**Reconciliation of Comments for RMRS-GTR-422**

**A Scenario-Based Assessment to Inform Sustainable Ponderosa Pine Timber Harvest on  
the Black Hills National Forest**

**By Mike Battaglia and Theresa Jain**

**June 24, 2021**

**Figure 1**—Net growth of major species on the Dixie National Forest

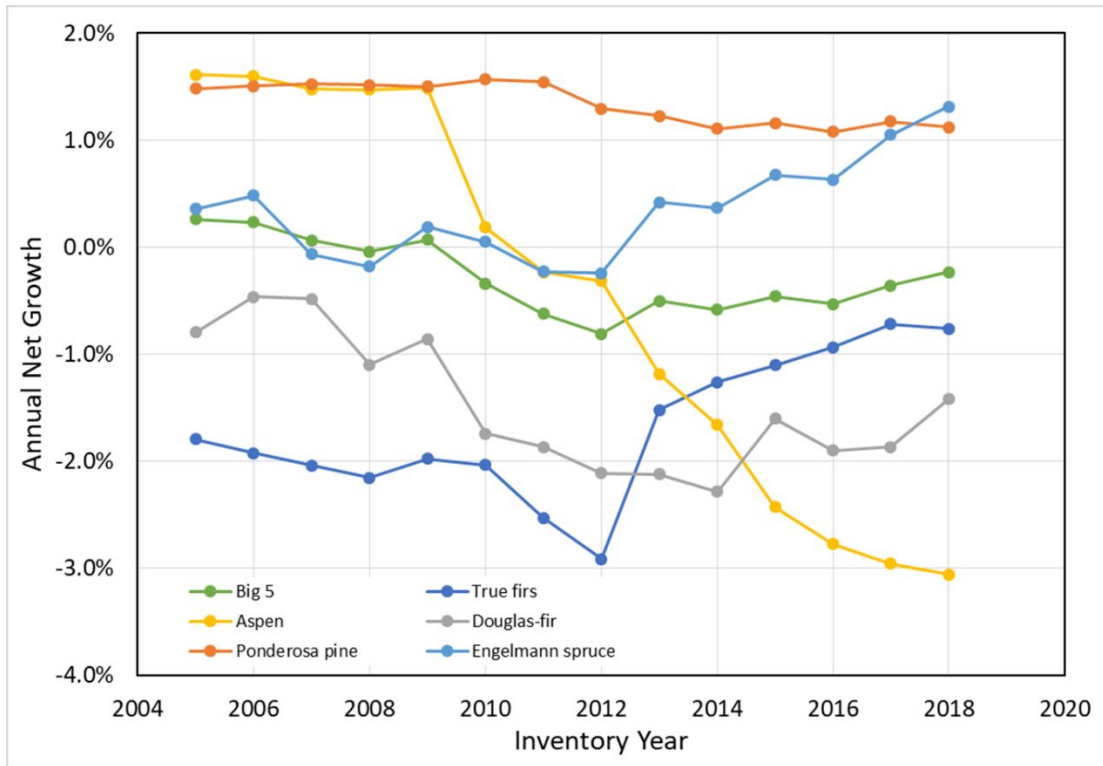
As shown in figure 1 above, mortality is the wildcard and is a very dynamic quantity in western forests. In the layout of alternative scenarios as shown in the report it is certainly fair to “smooth out” this variability and portray long-term averages. However, as shown in report figure 1 and figure 1 above, good times don’t last long, and overly optimistic scenarios are unlikely to play out. Some additional discussion to this effect would undoubtedly help consumers of the report understand the likelihood of the various scenarios.
